# The Sizewell C Project

SZC Co.'s Response to the Secretary of State's  
Request for Further Information dated 18 March  
2022: Appendix 3 - The Drainage Strategy  
Part 5 of 12

## **ANNEX 2A.7: SOUTHERN PARK AND RIDE DRAINAGE DESIGN NOTE**

DESCRIPTION  
**SIZESWELL C SOUTHERN PARK AND RIDE SITE DRAINAGE LAYOUT**

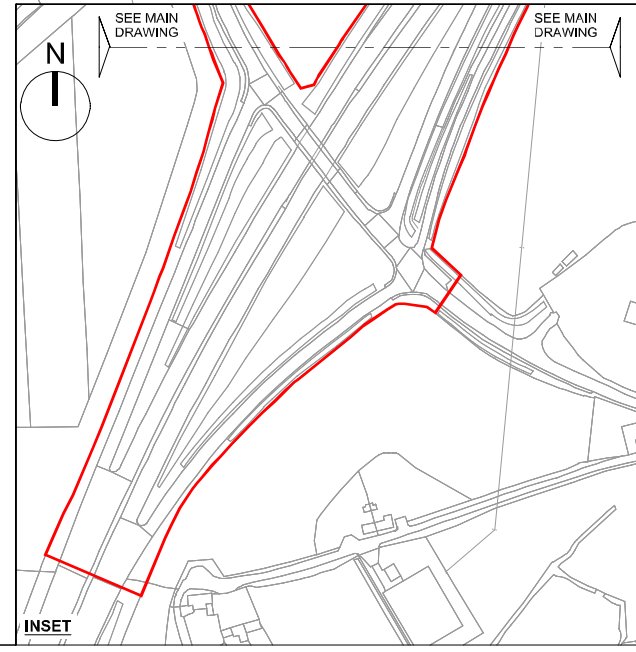
SCC Comments on Drainage Strategy shown in Appendix B	SZC Response
<p>Southern Catchment WTP217, which has been used for design purposes, is not compliant with BRE365. Only one test was undertaken, with the subsequent two tests failing to reach 25% and therefore not achieving an infiltration rate. The design for the southern catchment is entirely reliant on the first result from WTP217 which was <math>2.94 \times 10^{-5}</math> (105.84mm/hr). We cannot accept a design which is entirely reliant on results of non-compliant BRE365 testing, also noting that the first test which you've used for design would be a massive overestimation compared to the subsequent two results, had they reached 25%. Also, worth noting that WTP01 &amp; WTP03 failed as this gives further context to the above, although I note the recorded geology differs I'm not entirely sure what a 'crate basin' is, as shown in Appendix C.</p> <p>Northern catchment Looks acceptable in principle as the infiltration potential is proven at this location</p> <p>Pollution mitigation I don't think it's accurate to compare this to Northern Park and Ride. Northern Park and Ride discharges through multiple swales and basins before discharging through a positive outfall. At this location there's the potential for infiltration straight to ground without adequate treatment. It looks like most areas are proposed to pass from either swale or permeable paving and then into attenuation basins. Permeable paving shouldn't be an issue but the swales may need to be lined, especially along the access roads. This shouldn't be a problem as I note the calcs don't allow infiltration from these features anyway</p> <p>Plan in Appendix C still notes pumping station</p>
